DELEGATED DECISIONS BY CABINET MEMBER FOR TRANSPORT MANAGEMENT

17 JULY 2025

PROPOSED SHARED-USE CYCLEWAY/FOOTWAY – GROVE ROAD, WANTAGE

Report by Director of Environment and Highways

LIDLWANTAGE.2/04

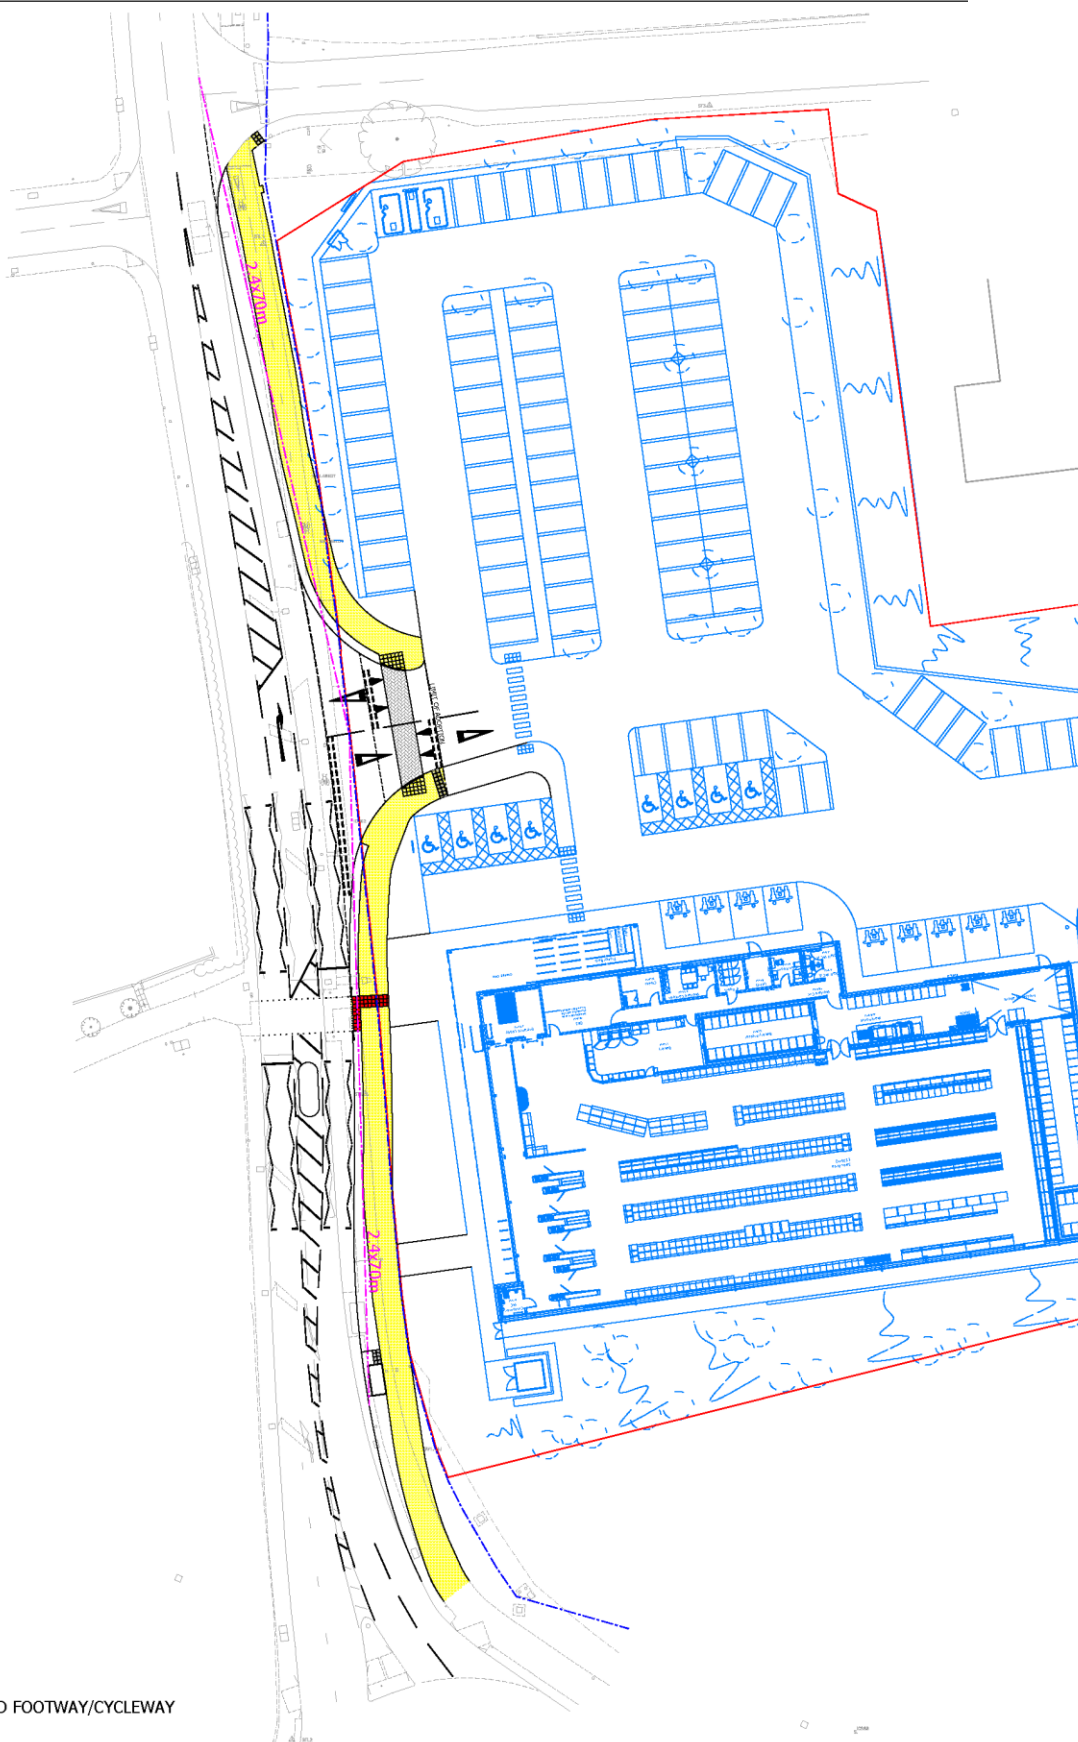
14. In response to comment o10, the proposed shared footway/cycleway will be constructed to a width of 3.0 metres, which complies with OCC's standards and the national guidance set out in LTN 1/20. Regarding the second concern raised, the speed limit wouldn't need to be reduced to facilitate these proposals as the existing speed limit is 30mph and there are adequate footway and cycleway provisions away from the carriageway.

15. In response to comment 'o11', shared footway/cycleways are compliant with both OCC and national design standards. Appropriate warning signage has been incorporated into the scheme to alert cyclists that they will be sharing the route with pedestrians and vice versa. The proposed layout has also been reviewed as part of an independent Road Safety Audit, which raised no concerns.

17. In response to comments 'o1' and 'o14'. The proposed junction prioritises pedestrians and cyclists, in line with OCC's standard approach for new junctions of this nature across the county. The design adheres to LTN 1/20 and reinforces Rule H2 of the Highway Code, which requires drivers to give way to pedestrians crossing or waiting to cross at junctions. The layout has also been reviewed through an independent Road Safety Audit, which identified no safety issues.

18. Regarding comment 'o3', at the point vehicles exit Wolage Drive travelling south, this will be a single white line and not hatching. In relation to the second concern the exit of the Lidl access will not be a mandatory left turn out, if it is found that there is an issue surrounding this after construction, OCC may consider this at that time. Regarding the third concern the amendments to the signalised crossing have been reviewed and approved by OCC's Traffic Signals officer.

19. In response to comment 'o9', a dedicated right-turn lane will be provided as part of the access works to accommodate vehicles entering the store. For the second concern, please refer to the response to comment 17 above, the crossing type has been assessed and determined at the planning stage. A signalised junction would not be appropriate and would discourage active travel. Regarding the third concern, vehicle tracking has been undertaken and demonstrates that HGVs can safely enter and exit the site.
